## MODEL 281 XP

## NEW AV-SYSTEM

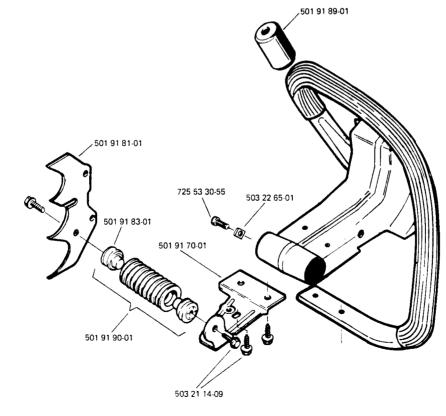
A new AV-system is introduced, in order to improve the vibration level. The two front AV-elements of rubber are replaced by one AV-element in spring design and two movement limiters. A rubber support is also added on the front handle.

New Ref. No.	Denomination	Excluded Ref. No.	Remark
501 91 81-01	Spike	501 80 84-01	
		501 81 93-01	
501 91 90-01	AV-element		
501 91 70-01	Support		Rebuilding kit
503 22 65-01	Nut		503 45 41-01
501 91 89-01	Rubber support		
725 53 30-55	Screw		
503 21 14-09	Screw	503 21 14-01	
501 91 83-01	Spring insert		
501 91 84-01	Spike, outside	501 80 85-01	
		501 81 94-01

To be able to modify the model 181, we have a separate rebuilding kit available, which contains the above mentioned parts. Reference number 503 45 41-01.

Note that an attachment hole for the support  $\emptyset$  4.7 mm must be drilled in the tank, when mounting the screw in the rear attachment hole in the support. Furthermore the groove in the tank, for the front handle, must be increased by 3 mm (.120") towards the front.
